Tasmania Fire Service

Bushfire Risk Unit

File No: AD3696

DRAFT CLARENCE LOCAL PROVISIONS SCHEDULE – DIRECTIONS TO THE TASMANIA FIRE SERVICE

Sandford Rural Living Zone - Minimum Lot Size proposed to be reduced from 2ha to 1ha under the Draft Clarence Local Provision Schedule 2020

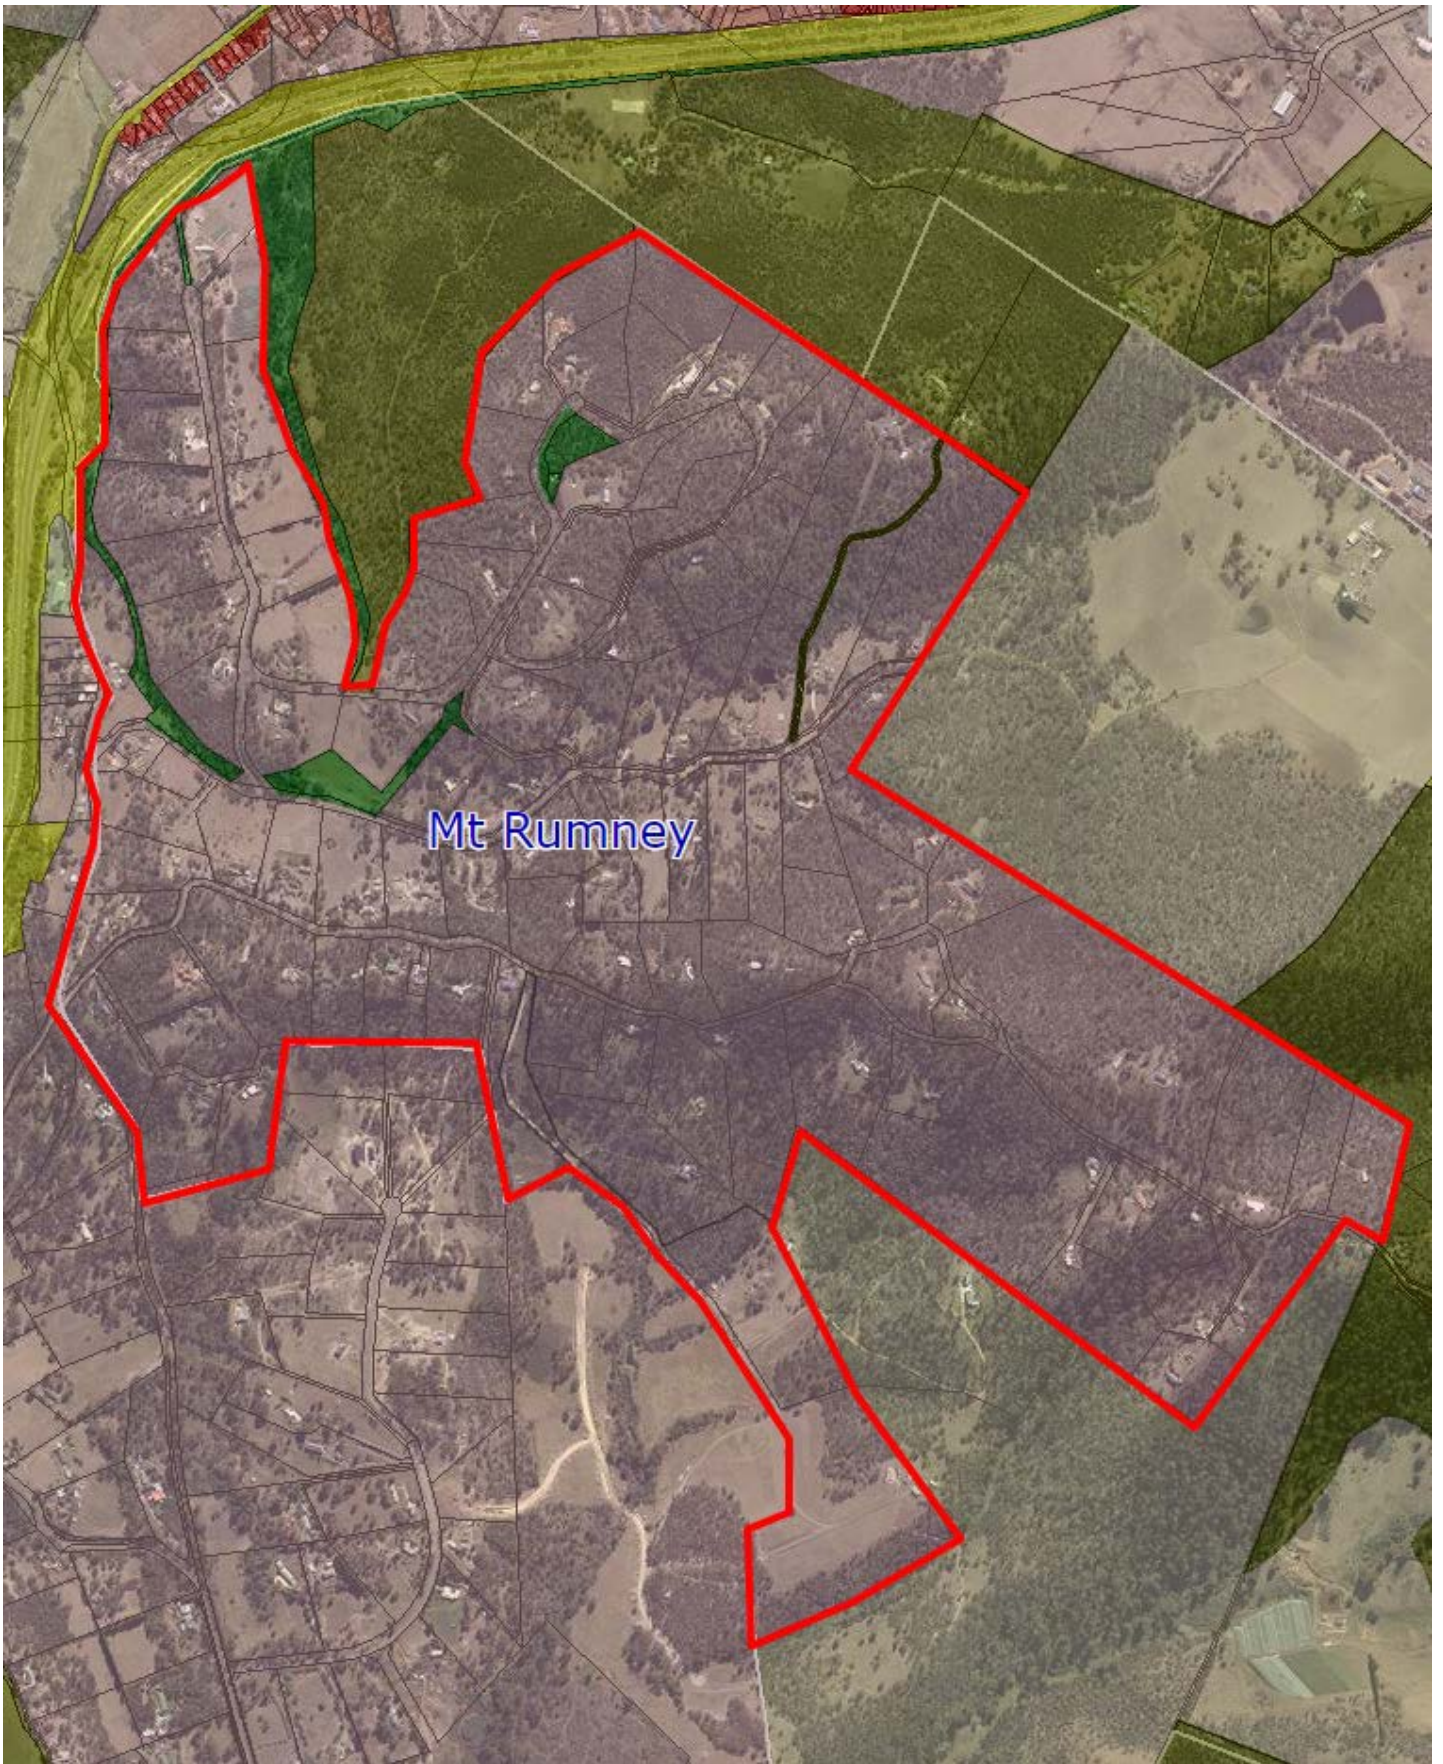
Tasmania Fire Service is particularly concerned with the proposed rezoning of land at Mount Rumney, Geilston Bay and Sandford from Rural Living (Area B) to Rural Living (Area A).

The proposed changes would reduce the minimum lot size requirement in these areas from 2ha to 1ha. Council has estimated that the additional lot yield would be in the order of:

- Mount Rumney – 92 additional lots;
- Geilston Bay – 16 additional lots; and
- Sandford – 288 additional lots.

At Mount Rumney the existing road infrastructure services a larger population that also has severely limited access/egress options. Sandford's road network is slightly better in that no-through roads are generally shorter and there are some available alternate access/egress routes.

Firefighting water supplies are limited to static supplies that are dispersed across some existing lots at Geilston Bay and Sandford and no analysis has been provided of TasWater's reticulated system at Mount Rumney.

The merit of intensifying development in highly exposed locations that are serviced by sub-optimal access/water infrastructure at Geilston Bay, Mount Rumney and to a lesser extent Sandford is questionable. It is recommended that the Commission does not support the proposed rezoning of these areas at this time.

Should Council wish to pursue the intensification of development at Geilston Bay, Mount Rumney or Sandford it is recommended that this be done as a separate scheme amendment process following more analysis of risk exposure, infrastructure, investment in mitigation measures and impacts on associated planning values.

Mt Rumney Rural Living Area proposed for minimum lot size to be reduced from 2ha to 1ha

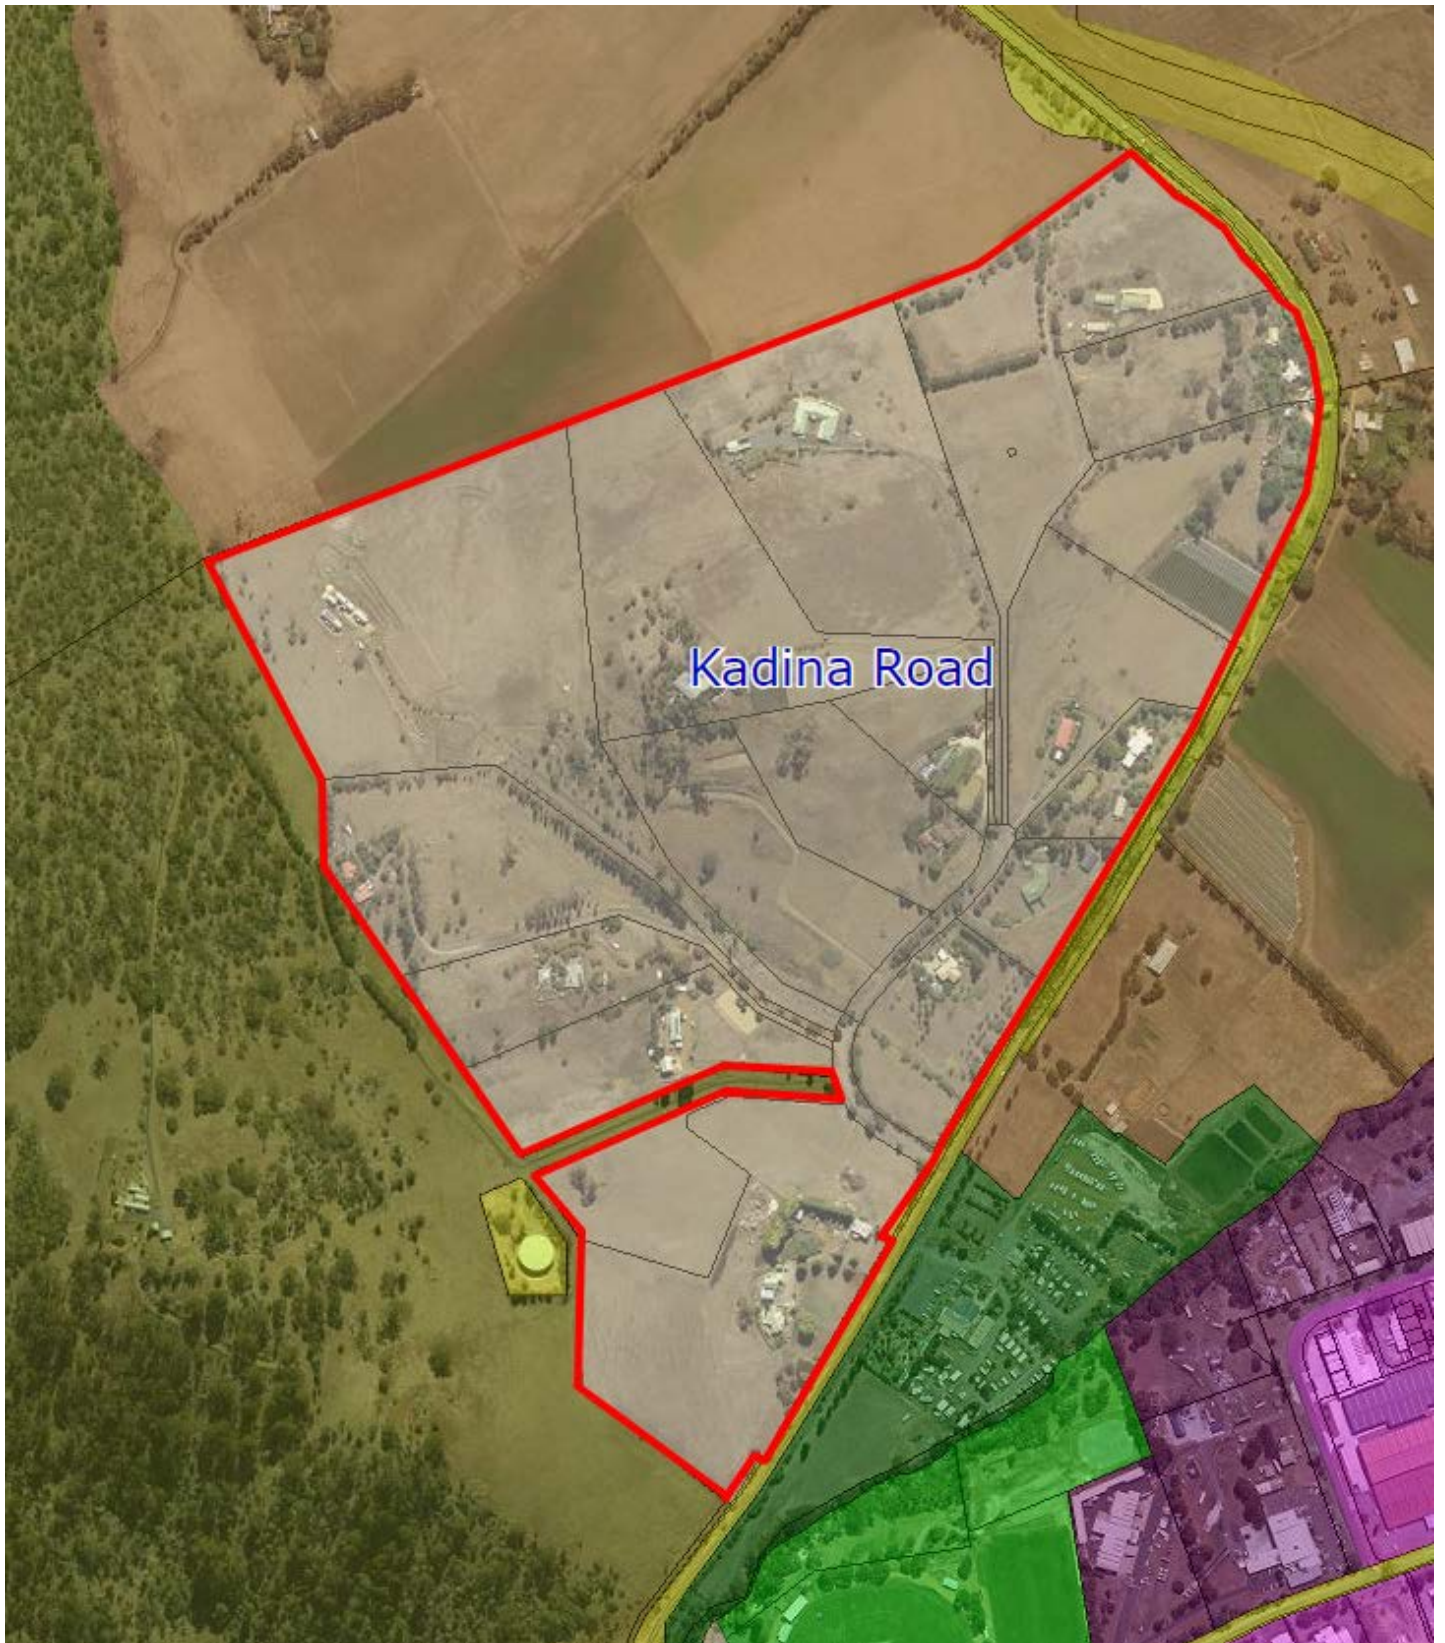
In each of these areas the existing settlement pattern is characterised by scattered low density residential dwellings within bushland. The existing subdivision patterns at Mount Rumney and Geilston Bay in particular has positioned existing dwellings upslope of surrounding bushland on steep topography.

It is also noted that there has been no consideration given to the potential cumulative impacts associated with additional vegetation clearance within the Biodiversity Protection Overlay that applies at Geilston Bay and Mount Rumney.

Kadina Road proposed to be zoned from Rural Resource to Rural Living with a minimum lot size of 1 ha

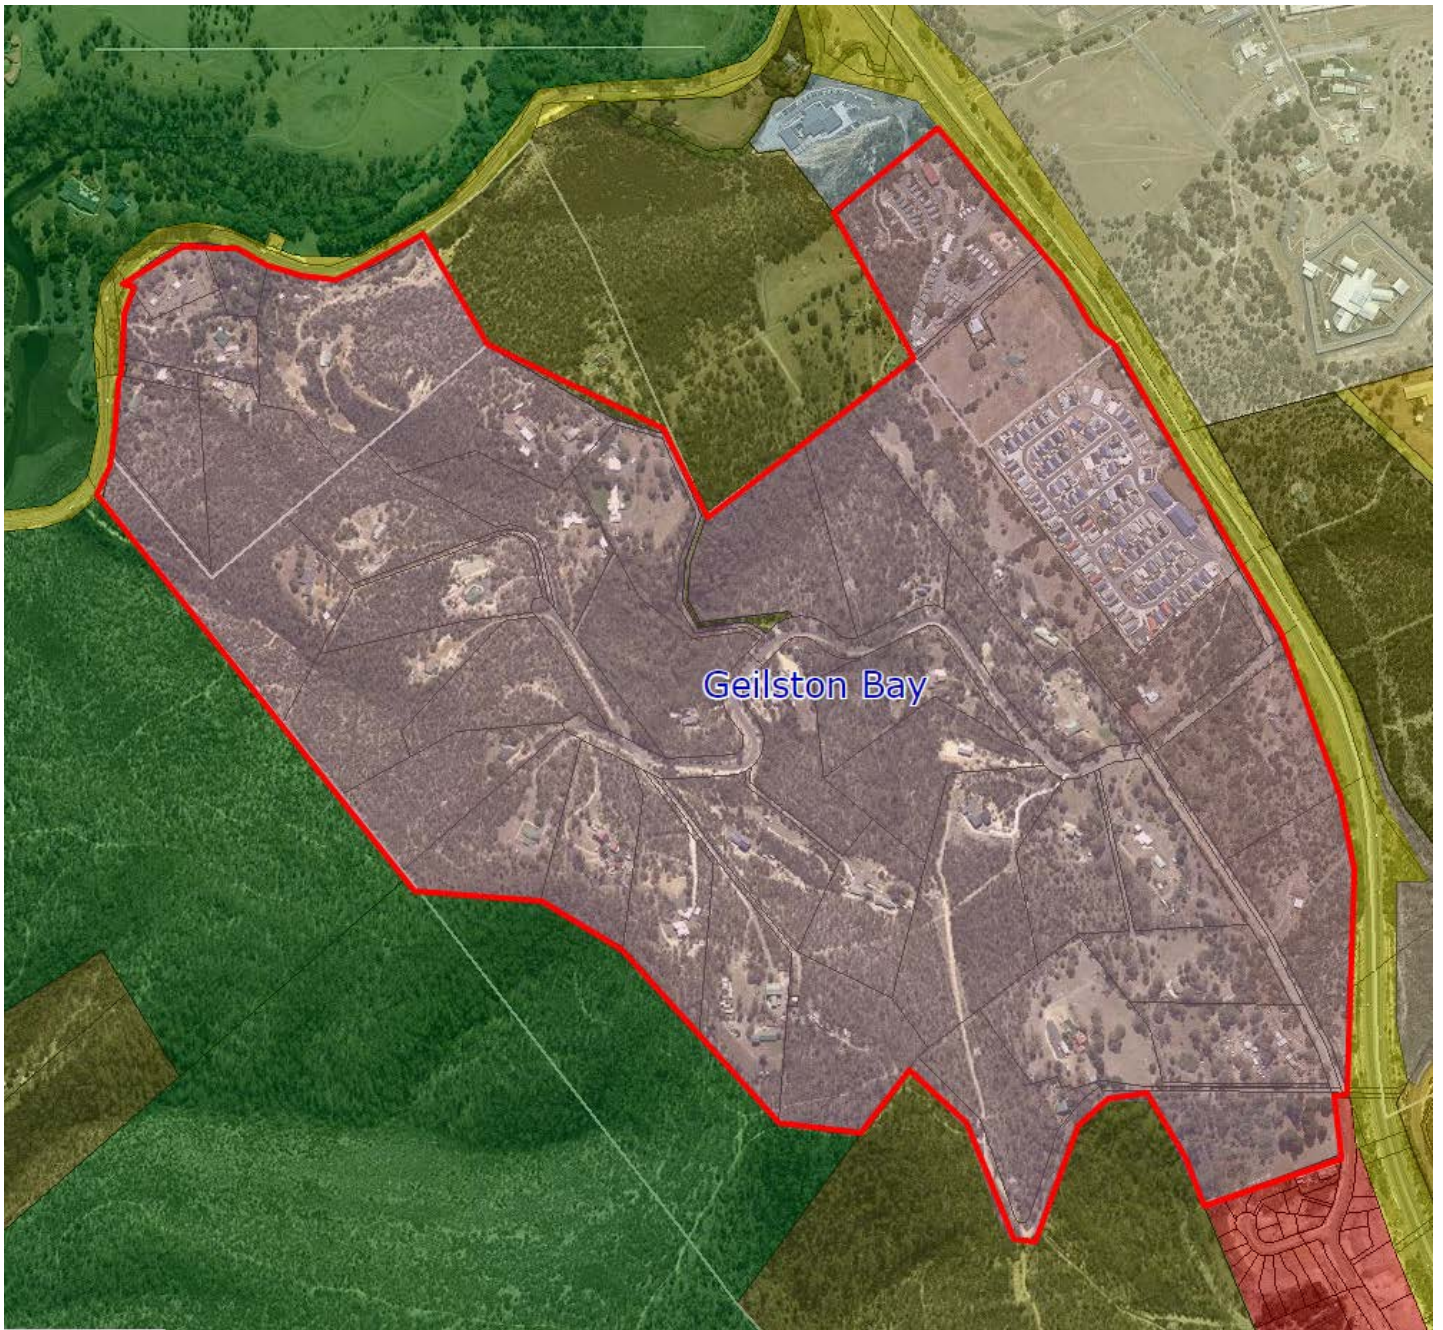
As with the preceding areas discussed above, it appears that no consideration has been given to bushfire risks associated with the proposed rezoning of the Kadina Road settlement.

The Kadina Road area is significantly less exposed than the previously discussed areas. Whilst access is limited to Kadina Road, the length of this street is not prohibitive and it provides a clear access/egress route away from the likely direction of attack. There are unlikely to be any major constraints in terms of occupant evacuation or emergency intervention in this area should further subdivision occur.

The proposed rezonings at Kadina Place and at Lindisfarne Ridge/Flagstaff Gully are considered to be less problematic due to their respective locations and existing infrastructure and are generally acceptable to Tasmania Fire Service.
